service bulletin

No. 98-1

Power Trim Piston/Rod Replacement P/N 43397A6

1998 135 - 250 HP

- a - Fill cap
- b - Manual valve
- c - Date code location
- d - Factory rework mark (white dot)
- e - Port trim ram

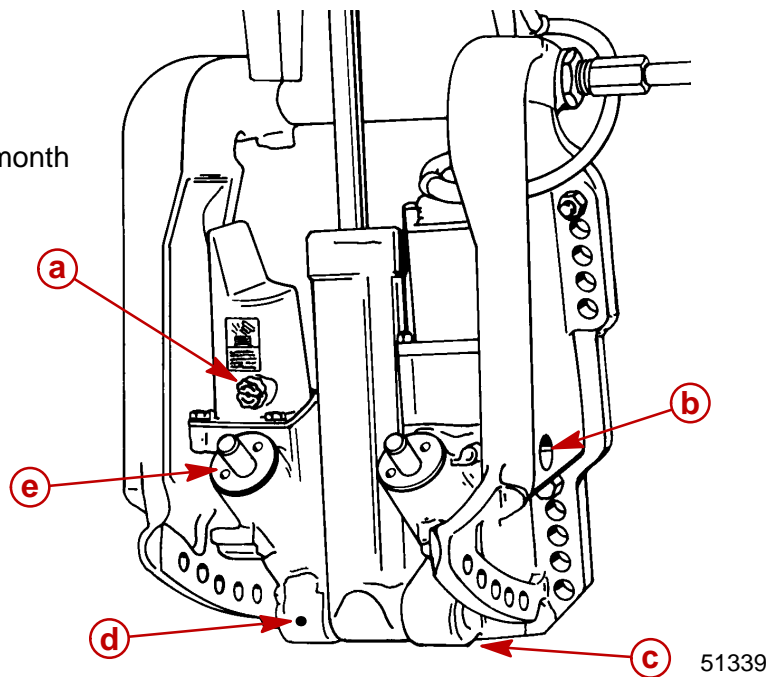
Any engine that **DOES NOT** have the factory rework marking, should have the anode assembly removed from the power trim, to inspect for affected date codes. Affected date codes are 7I02 thru 7K07. Power trims with date codes that are not in the affected range do not require trim piston/rod replacement.

7 K 07

year month day of month

- a - Trim rod removal tool (91-44486A1)
- b - Spanner Wrench (91-74951)
- c - Cap removal tool (91-44487A1)

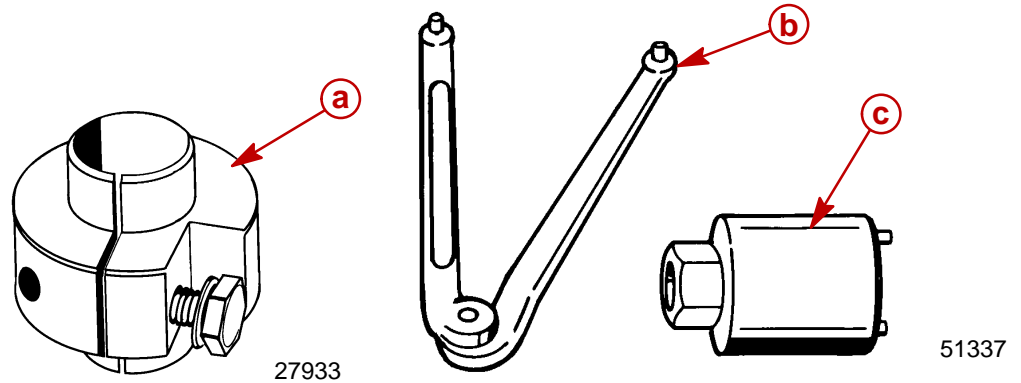
Loosen the port side trim rod cylinder cap using spanner wrench (91-74951), or cap removal tool (91-44487A1). Before removing , clean any dirt or loose paint chips from around cap area.

Install trim rod removal tool (91-44486A1) and pull trim piston/rod assembly from cylinder.

Install cylinder cap over new piston/rod assembly.

Apply Quicksilver Power Trim and Steering Fluid on all O-rings and seals before installation.

Install trim rod and cap.
